UNITED STATES PATENT AND TRADEMARK OFFICE

APPLICATION NO.	FILING DATE	FIRST NAMED INVENTOR	ATTORNEY DOCKET NO.	CONFIRMATION NO.
10/624,333	07/22/2003	Paul T. Van Gompel	659-1095	6978
757	7590	09/29/2005	EXAMINER	
BRINKS HOFER GILSON & LIONE P.O. BOX 10395 CHICAGO, IL 60610			GIBSON, KESHIA L	
			ART UNIT	PAPER NUMBER
			3761

Office Action Summary	Application No. 10/624,333	Applicant(s) VAN GOMPEL ET AL.	
	Examiner Keshia Gibson	Art Unit 3761

Fig. A: Examiner's mark-up of Nakahata's Fig. 2.

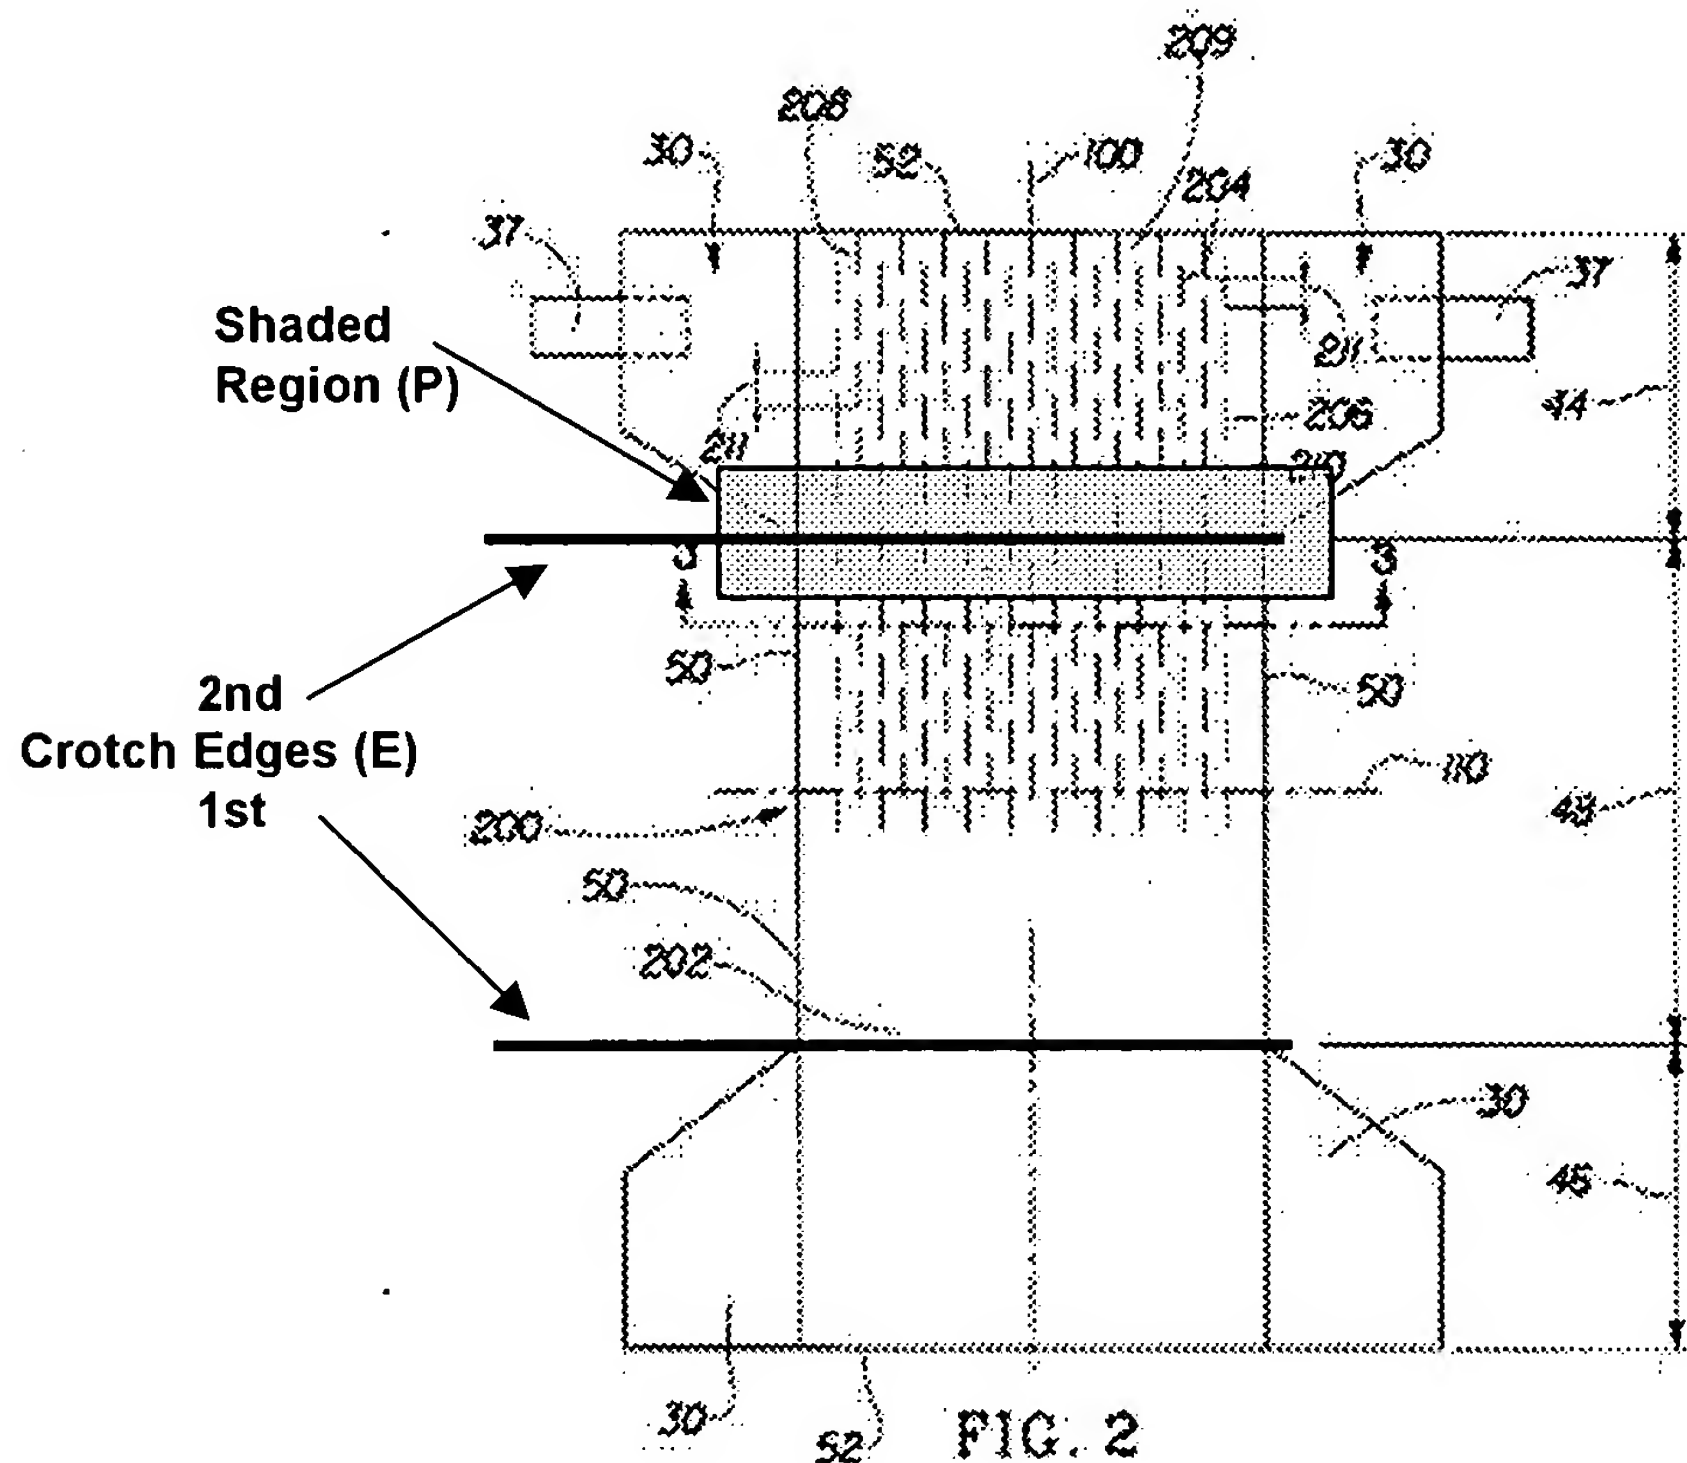
In regard to Claim 1, Nakahata discloses a disposable undergarment 20/200 comprising a front body panel 46, a rear body panel 44, and a crotch member 48 (Figs 1-2; column 3, lines 13-31). The front body panel 46 comprises a pair of opposite first laterally spaced side edges 50, a first waist edge 52, and a first crotch edge E longitudinally spaced from said first waist edge 52; the rear body panel 46 comprises a pair of opposite laterally spaced second side edges 50, a second waist edge 52, and a second crotch edge E longitudinally spaced from said second waist edge E (Fig. 2 and Fig. A below; column 3, line 13-31). The first and second crotch edges E are longitudinally spaced from each other (Fig. A). The second crotch edge E comprises at least one longitudinally extending slit 206 formed therein (see region P in Fig. B below; column

11, lines 1-29). A crotch member 48 is connected to the front and rear body panels 46, 44 and further comprises slits 206 (Fig. 2; column 11, lines 1-29). When viewing the undergarment 20 from the garment-facing surface 26, the crotch member 48 covers the slit(s) 206.

Fig. 4

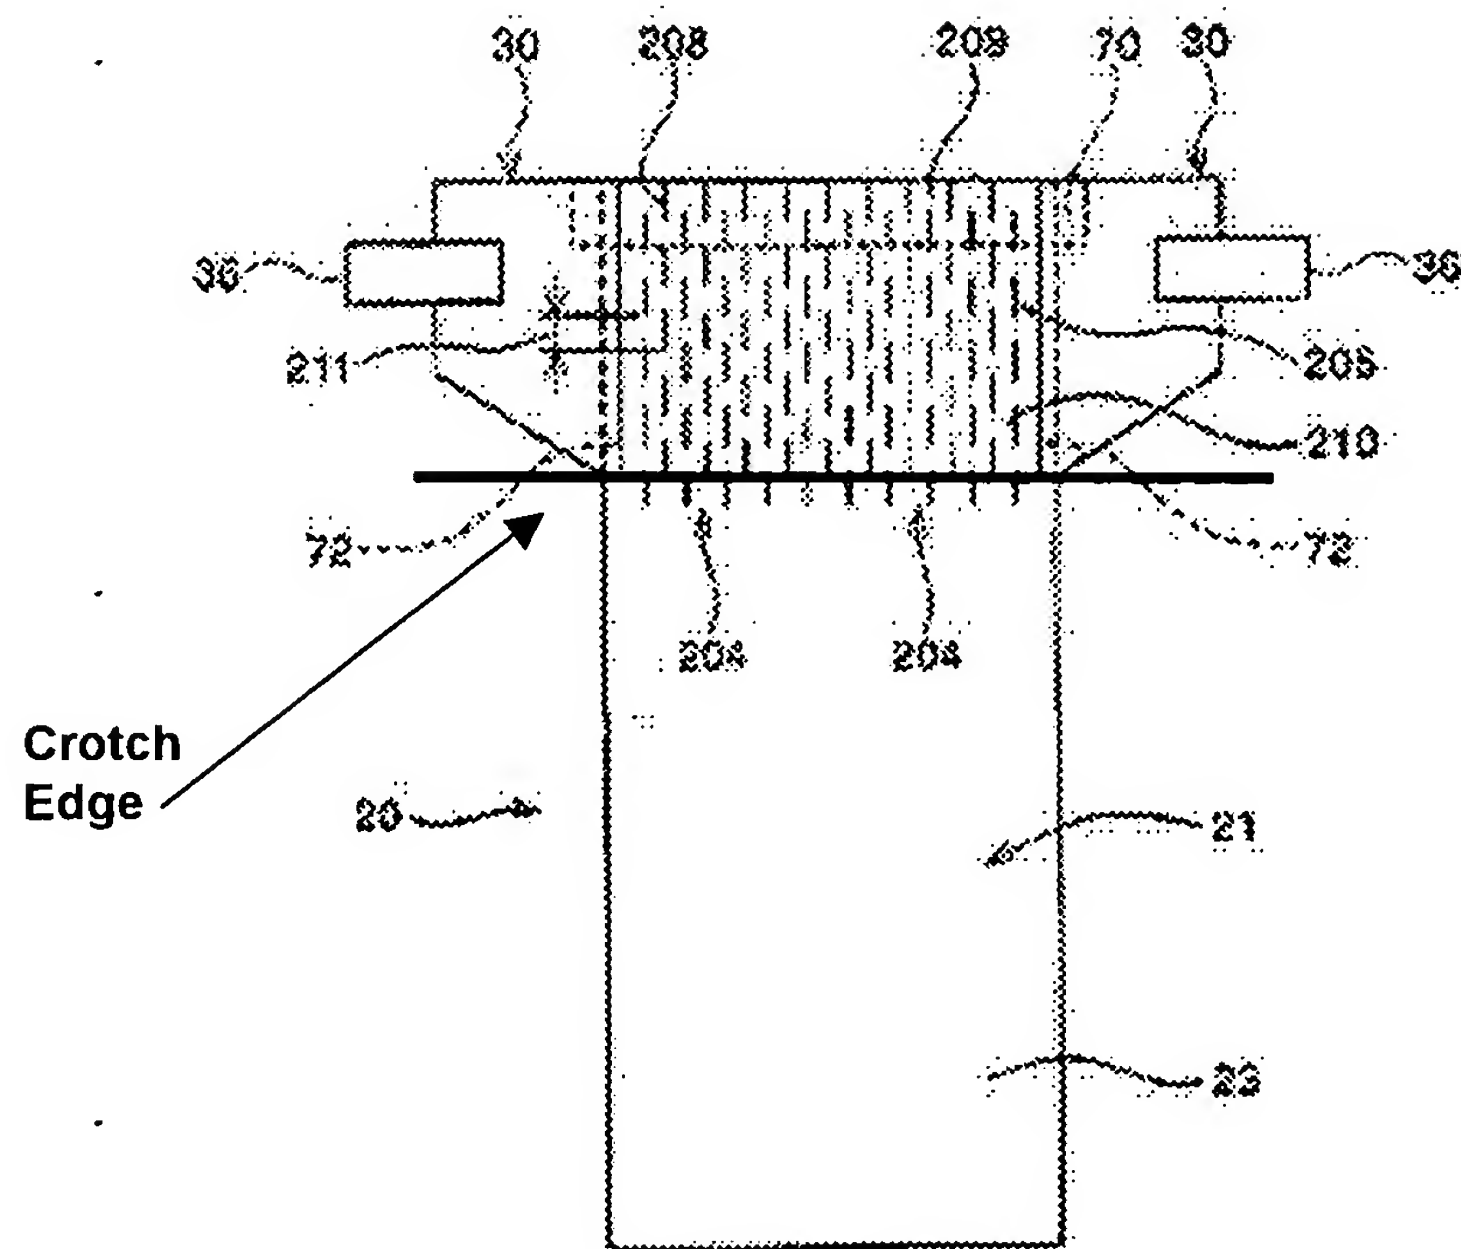
In regard to Claim 1, Nakahata et al. disclose a disposable undergarment 20 comprising a front body panel 45, a rear body panel 43, and a crotch member 47. The front body panel 45 comprises a pair of opposite first laterally spaced side edges 50, a first waist edge 52 and a first crotch edge (dotted line between front body panel 45 and crotch panel 47 in Fig. 2) longitudinally spaced from said first waist edge 52 (Figs. 1-2). The rear body panel 43 comprises a pair of opposite laterally spaced second side edges 50, a second waist edge 52 and a second crotch edge (dotted line between rear body panel 43 and crotch panel 47 in Fig. 2) longitudinally spaced from said second waist edge 52 (Figs. 1-2). The first and second crotch edges are longitudinally spaced from each other (Fig. 2). The second crotch edge comprises at least one longitudinally extending slit 206 formed therein (Figs. 4-6; Fig. B below). The crotch member 47 connected to the front and rear body panels 45, 43 and covers at least one of the slits 206 (Figs. 1-2, Fig. B below). When viewed for the body-facing surface (such as in Fig. 1), the crotch member covers the slits 206.

In regard to Claim 6, Nakahata discloses that the rear body panel 45 comprising slits 206, further comprises a back sheet 21 made of an elastic material (Figs. 4-6 and Fig. B; page 6, lines 30-31). The rear body panel 45 is expandable between at least a first and second condition Fig. 4, Fig. 5, wherein a pair of edges defining the slit 206 are substantially abutted when the rear body panel 45, comprising an elastic material, is in the first condition Fig. 4, and wherein the pair of edges defining the slit 206 are
